New location of final assembly and new country of origin of various fuse holder parts.

Product Change Notification					Relocation of production		
owner	creation date	release date	released by	change order no	rev	page	D10-003-914
dislercy	2016-05-04	2016-06-09	bergerra	2009947	A	1 of 2

Label adjustment:

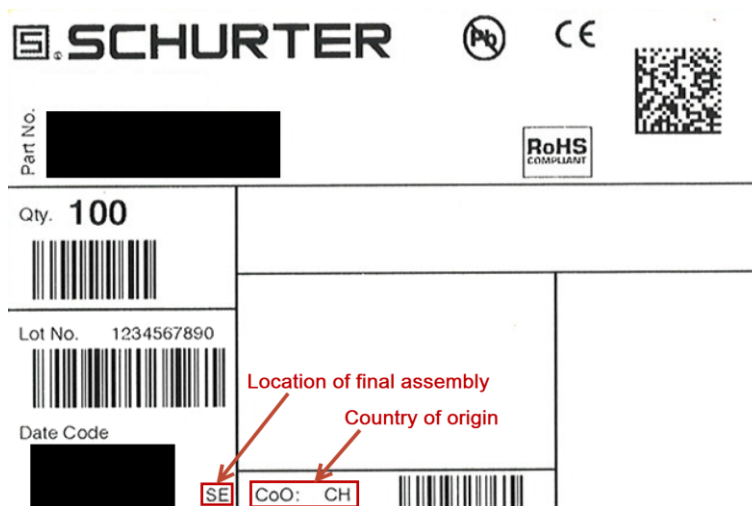
The location of final assembly and the country of origin of various fuse holders change from Switzerland to Czech Republic.

Form	No	There are no form changes
Fit	No	There are dimensional changes
Function	No	This is a non-functional change
Production Site	Yes	Relocation of final assembly from CH to CZ
Product Label	Yes	Adjustment of the label if the location of final assembly and/or the country of origin changes
Customer Action	No	Notification only
